**ADDENDUM NO. 1
NEW ELEVATOR
AT MURPHY ELEMENTARY SCHOOL
ROUND LAKE SCHOOL DISTRICT NO. 116
PROJECT NO. 23170**

Board of Education
Round Lake School District 116
884 West Nippersink Road
Round Lake, Illinois 60073

2 PARTIAL FIRST FLOOR ELECTRICAL PLAN
 1/4" = 1'-0"

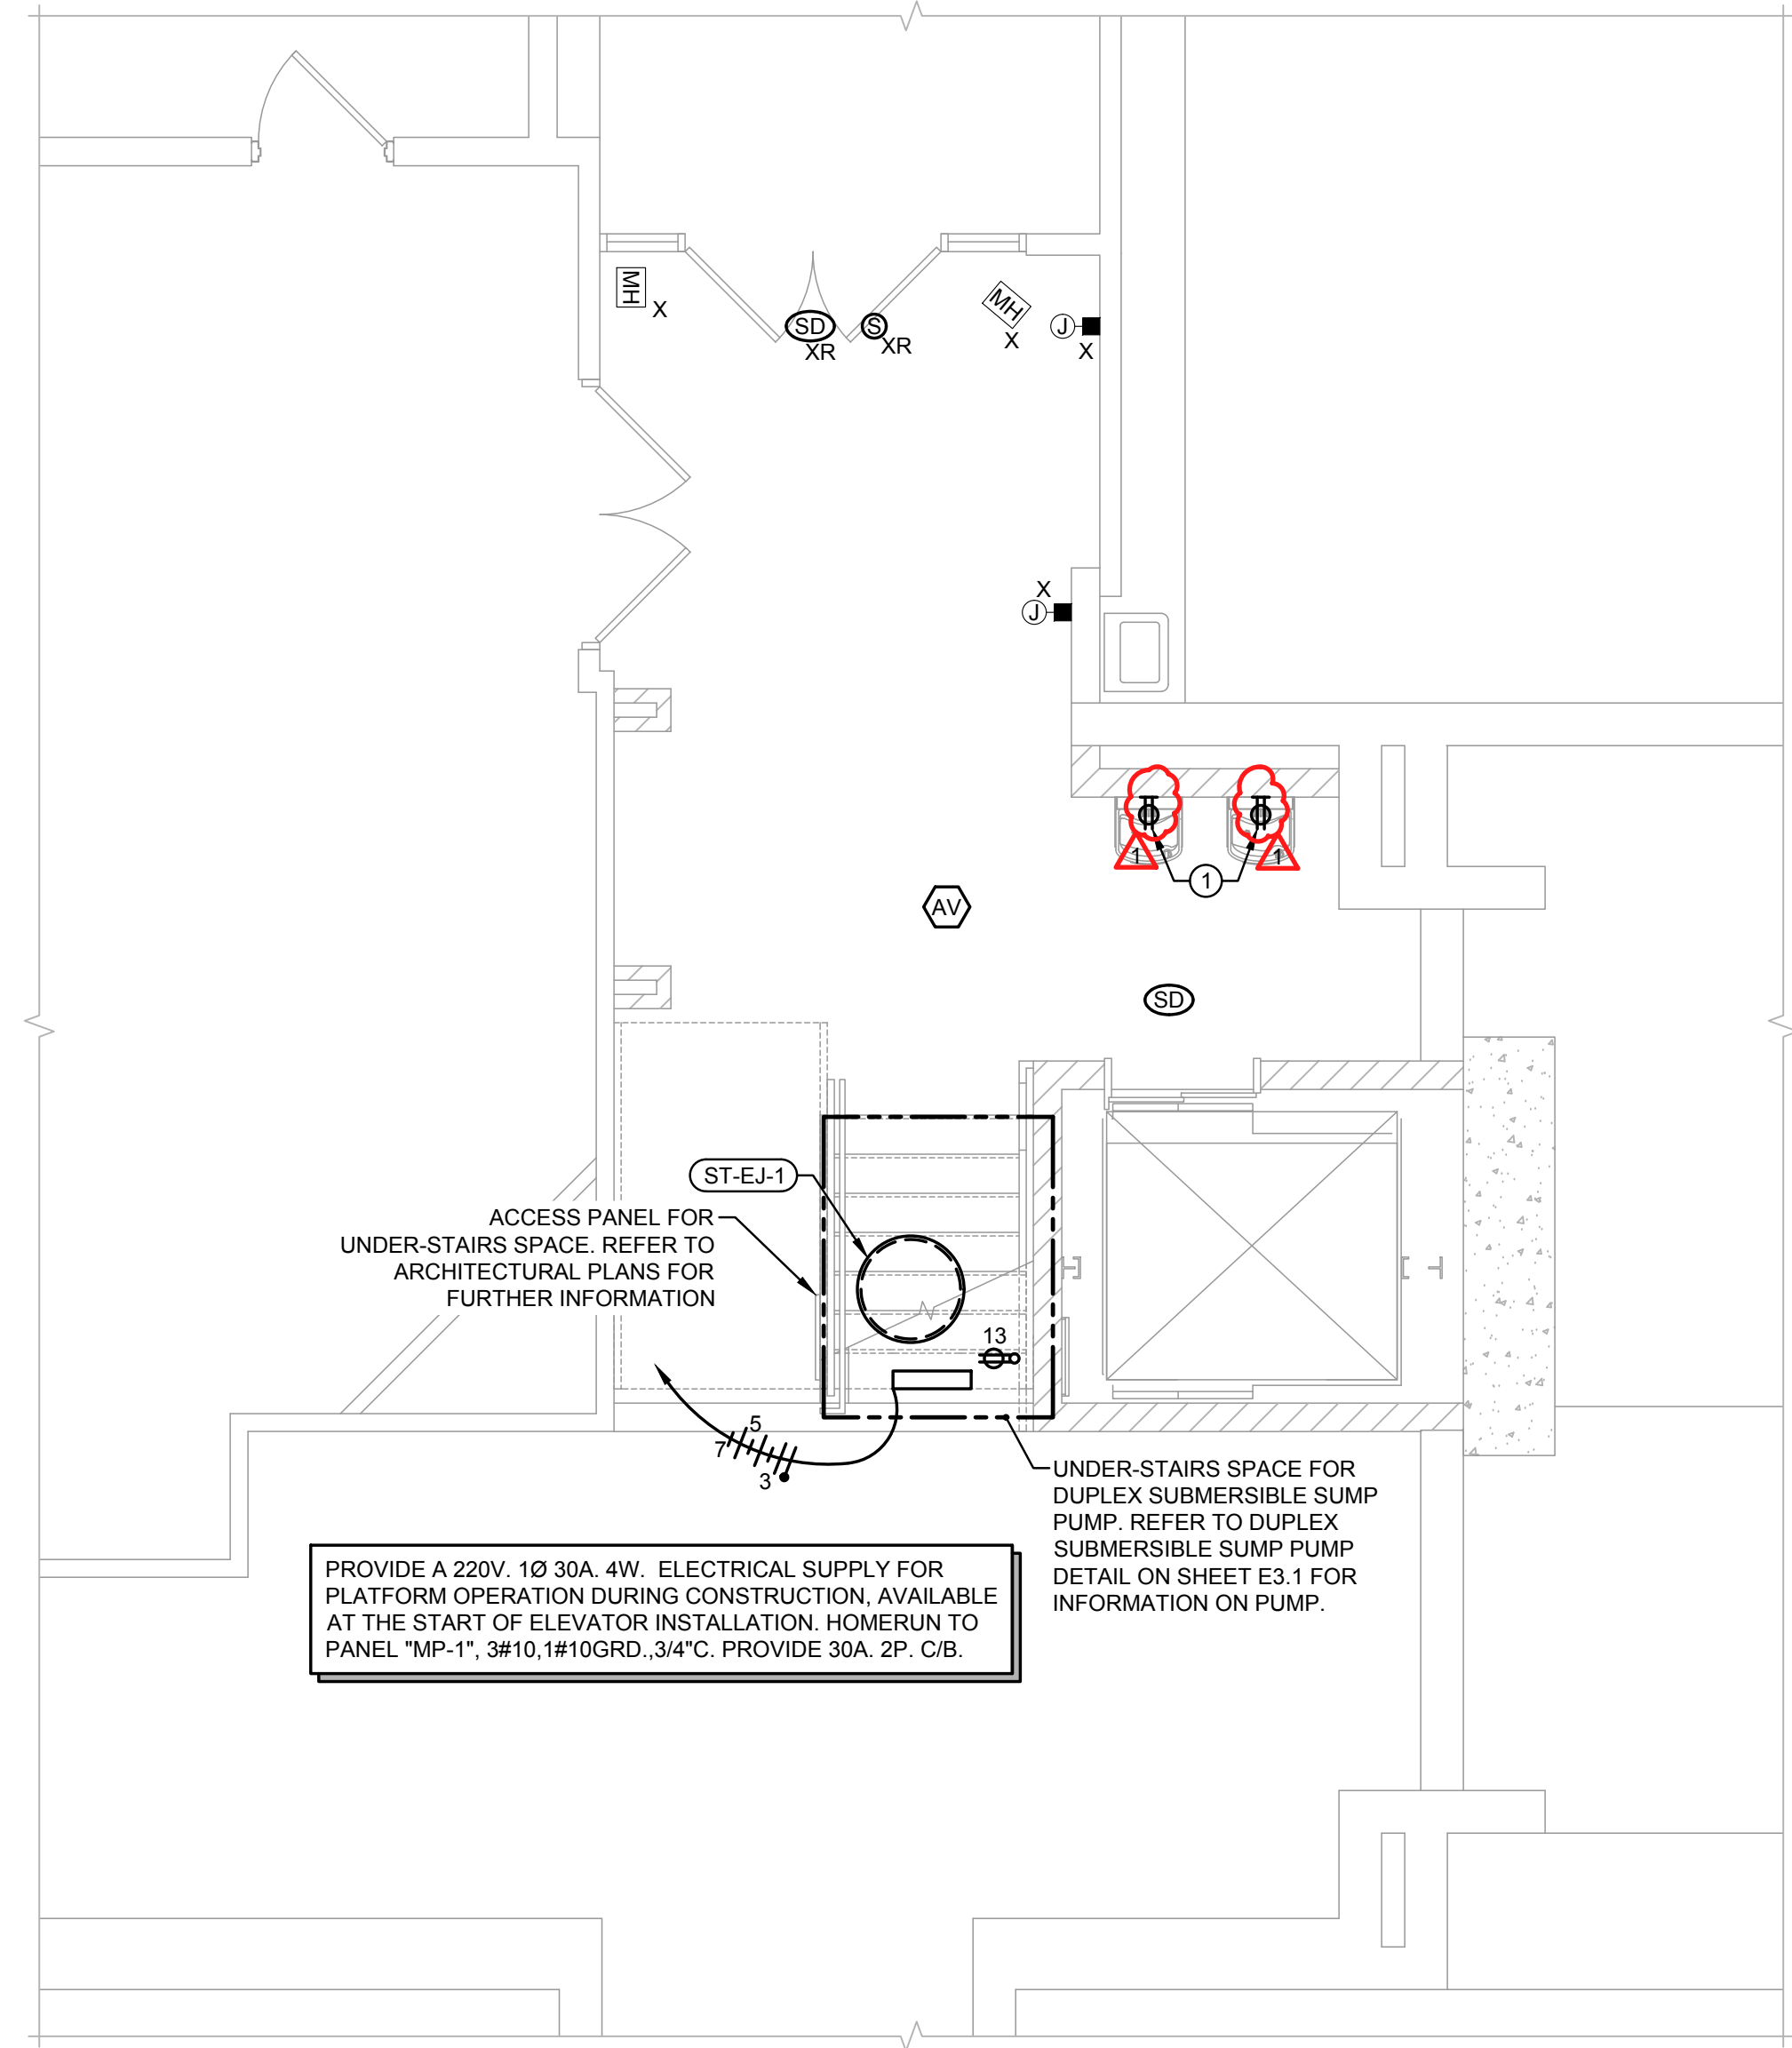
ITEM NO. 10: PROJECT DRAWINGS, E1.1, PARTIAL ELECTRICAL PLANS

1. Refer to attached drawing E1.1 and refer to highlighted items for updates.
